**Hardin Park
Optimist Field**

ADA Checklist for Existing Facilities

Project: ADA Assessment Greenville TN

Building: Hardin Park Optimist Field

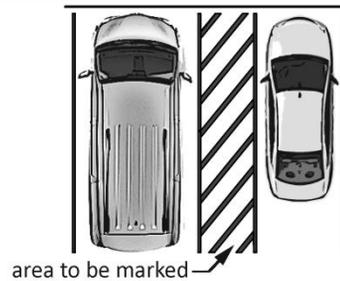
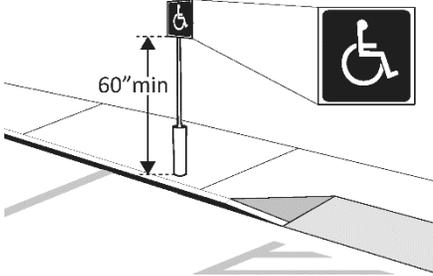
1.7 Are the access aisles marked so as to discourage parking in them?
[502.3.3]

Yes

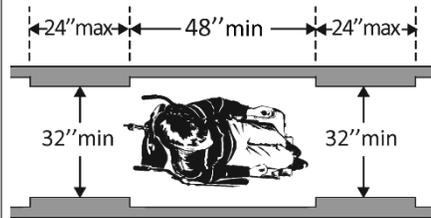
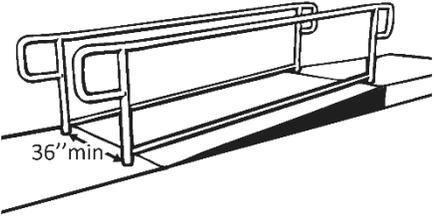
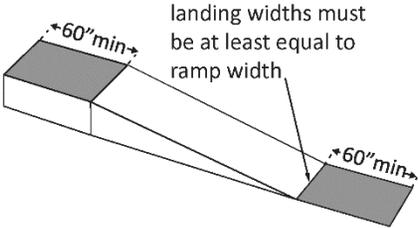
1.14 Is the route at least 36 inches wide?
[403.5.1]

Yes
Measurement:

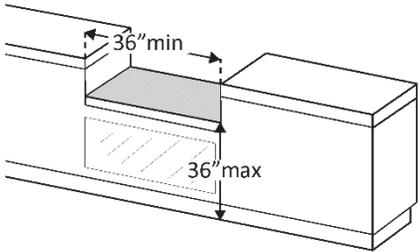
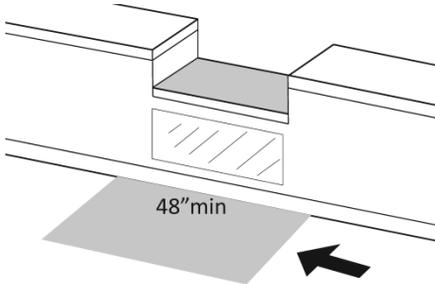
Ramps If any portion of the accessible route is steeper than 1:20, it should be treated as a ramp. From parking - Bleachers to left of press box only

<p>1.25 If there is a ramp is it at least 36 inches wide? [405.5]</p> <p>Note: If there are handrails, measure between the handrails.</p>	<p>Yes</p> <p>Measurement:</p>		<p>Photo #:</p>	
<p>1.26 Is the surface stable, firm and slip resistant? [405.4]</p>	<p>Yes</p>		<p>Photo #:</p>	
<p>1.27 For each section of the ramp, is the running slope no greater than 1:12, i.e. for every inch of height change there are at least 12 inches of ramp run? [405.2]</p> <p>Note: Rises no greater than 3 inches with a slope no steeper than 1:8 and rises no greater than 6 inches with a slope no steeper than 1:10 are permitted when such slopes are necessary due to space limitations.</p>	<p>Yes</p> <p>Measurement:</p>		<p>Photo #:</p>	
<p>1.28 Is there a level landing that is at least 60 inches long and at least as wide as the ramp: At the top of the ramp?</p>	<p>Yes</p> <p>Measurement:</p>		<p>Photo #:</p>
